Subject: Diablo Canyon Nuclear Power Plant - Issuance of Amendment No. 3 to
Facility Operating License No. DPR-80 (Unit 1) and Amendment No. 1
to Facility Operating License No. DPR-82 (Unit 2)

PACIFIC GAS AND ELECTRIC COMPANY
DIABLO CANYON NUCLEAR POWER PLANT, UNIT 1
DOCKET NO. 50-275
AMENDMENT TO FACILITY OPERATING LICENSE

PACIFIC GAS AND ELECTRIC COMPANY
DIABLO CANYON NUCLEAR POWER PLANT, UNIT 2
DOCKET NO. 50-323
AMENDMENT TO FACILITY OPERATING LICENSE

SAFETY EVALUATION BY THE OFFICE OF NUCLEAR
REACTOR REGULATION RELATED TO
AMENDMENT NO. 3 TO FACILITY OPERATING LICENSE NO. DPR-80
DIABLO CANYON UNIT 1, DOCKET NO. 275; AND
AMENDMENT NO. 1 TO FACILITY OPERATING LICENSE NO. DPR-82,
DIABLO CANYON UNIT 2, DOCKET NO. 50-323

FIGURE 3.2-1a

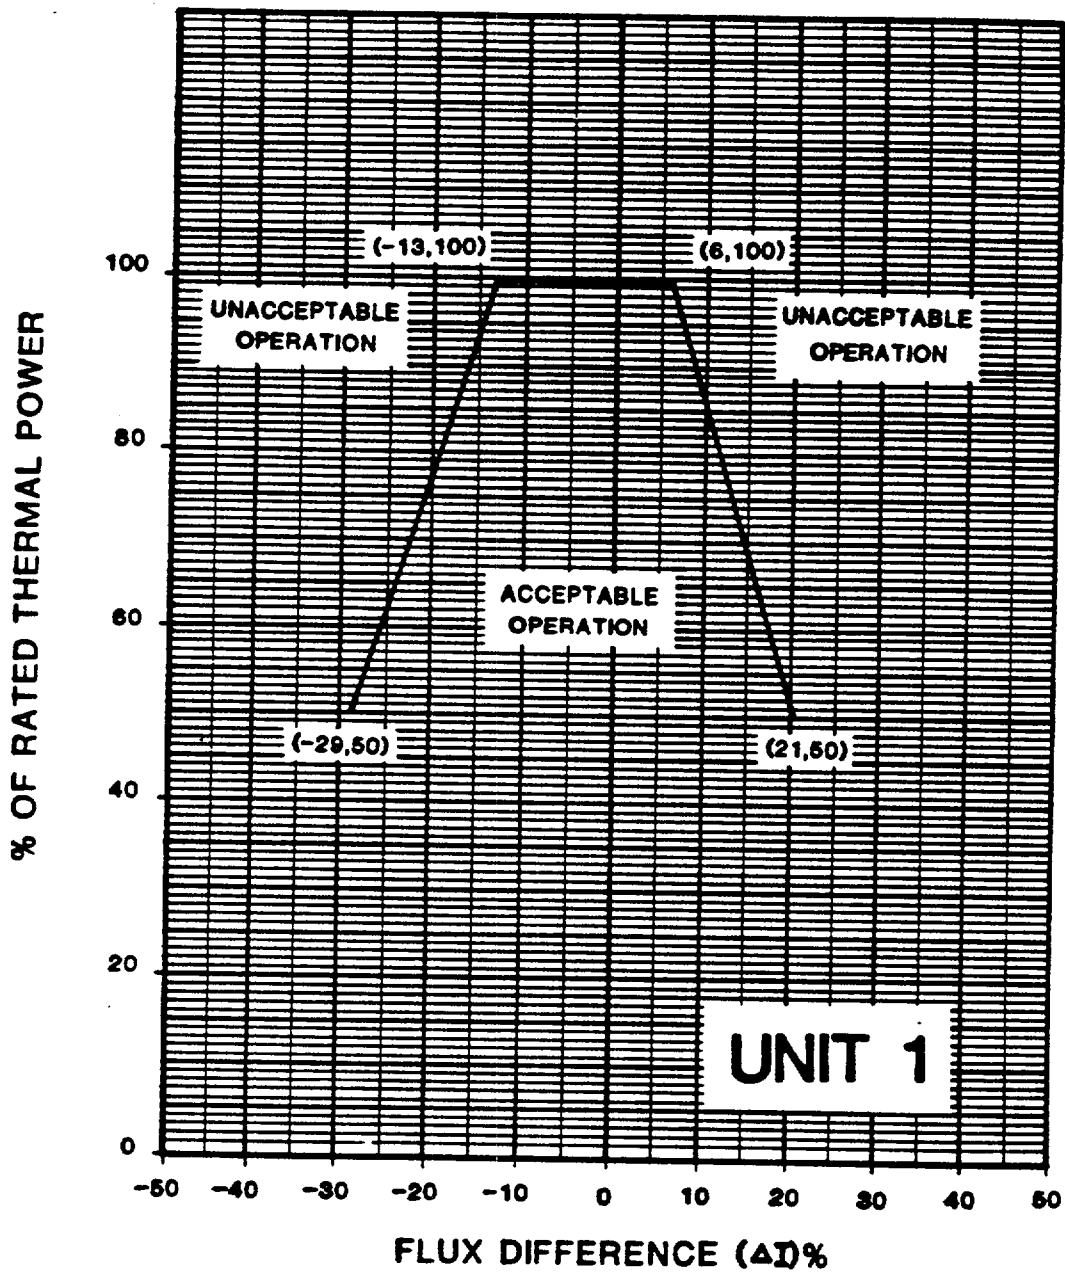
3.2.1.1 For Unit 1 the indicated AXIAL FLUX DIFFERENCE (AFD) shall be maintained within the allowed operational space defined by Unit 1 Figure 3.2-1a.

- a. With the indicated AXIAL FLUX DIFFERENCE outside of the Unit 1 Figure 3.2-1a limits,
 1. Either restore the indicated AFD to within the Unit 1 Figure 3.2-1a limits within 15 minutes, or
 2. Reduce THERMAL POWER to less than 50% of RATED THERMAL POWER within 30 minutes and reduce the Power Range Neutron Flux - High Trip setpoints to less than or equal to 55 percent of RATED THERMAL POWER within the next 4 hours.
- b. THERMAL POWER shall not be increased above 50% of RATED THERMAL POWER unless the indicated AFD is within the Unit 1 Figure 3.2-1a limits.

By letter dated September 6, 1985, (LAR 85-09) Pacific Gas and Electric Company (PG&E) requested changes to the Diablo Canyon Units 1 and 2 combined Technical Specification 3/4.2.1, "Axial Flux Difference". The changes would implement a Westinghouse developed power distribution control methodology called Relaxed Axial Offset Control (RAOC) for Diablo Canyon Unit 1 and would retain the existing Technical Specifications for Unit 2. The changes require an amendment to the Technical Specifications for both Unit 1 and Unit 2.

The staff has reviewed the Technical Specification changes proposed by PG&E for Diablo Canyon Unit 1 and finds they correctly implement RAOC. Since this represents the application of an approved methodology, the proposed Technical Specification changes are acceptable. As described by PG&E, the analysis, which applies to Diablo Canyon Unit 1 is applicable only after the unit reaches 8000 MWD/MTU burnup in Cycle 1 and thereafter until the end of Cycle 1. Specific evaluations for subsequent cycles must be made to determine if the allowable ΔI band curve remains valid or if further revisions are required by an additional Technical Specification change.

FIGURE 3.2-1b
UNIT 2 AXIAL FLUX DIFFERENCE LIMITS AS A
FUNCTION OF RATED THERMAL POWER

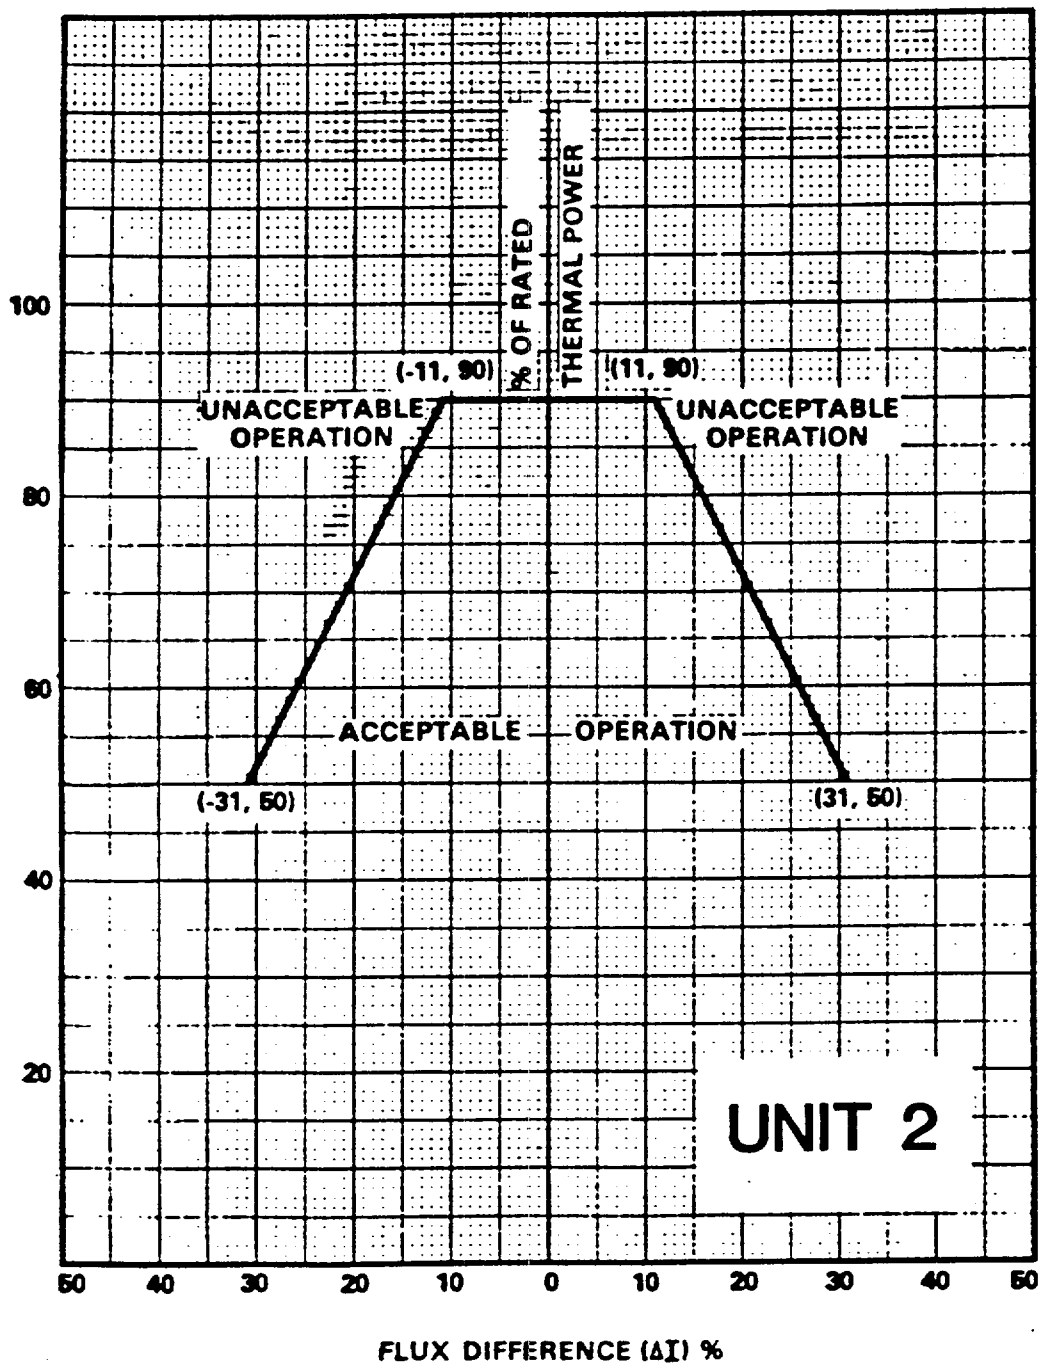
3.2.1.1 For Unit 2 the indicated AXIAL FLUX DIFFERENCE (AFD) shall be maintained within a $\pm 5\%$ target band (flux difference units) about the target flux difference when THERMAL POWER is above 50% of RATED THERMAL POWER. The indicated AFD may deviate outside the above required target based at greater than or equal to 50% but less than 90% of RATED THERMAL POWER provided the indicated AFD is within the Acceptable Operation Limits of Unit 2 Figure 3.2-1b and the cumulative penalty deviation time does not exceed 1 hour during the previous 24 hours.

#Surveillance testing of the Power Range Neutron Flux channel may be performed pursuant to Specification 4.3.1.1 provided the indicated AFD is maintained within the Acceptable Operation Limits of Unit 2 Figure 3.2-1b. A total of 16 hours operation may be accumulated with the AFD outside of the above required target band during testing without penalty deviation.

In addition to implementation of RAOC for Unit 1, the proposed changes also modify the existing Technical Specification 3/4.2.1 to remain applicable for Unit 2 only. This is an administrative change and is therefore acceptable also.
